FOUR WINDS ABOVE FLOOR SLIDEOUT SYSTEMS

L150 MOTOR

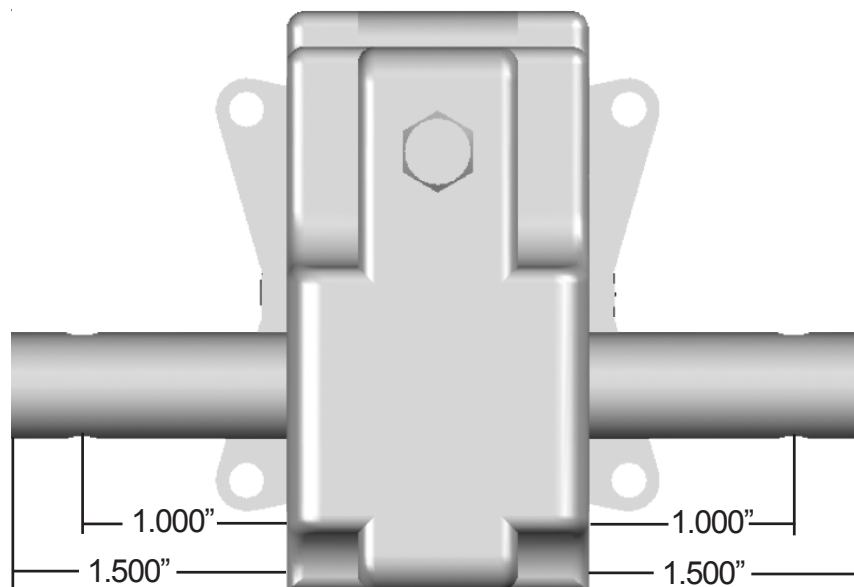
- 3b. If this system needs a bigger motor, the Klauber M150 and it must be modified (drive shaft must be cut down in length and a new drive shaft hole must be drilled. See L150 Motor below for specs on shaft length and hole location. Cross Shaft hole to be .250".
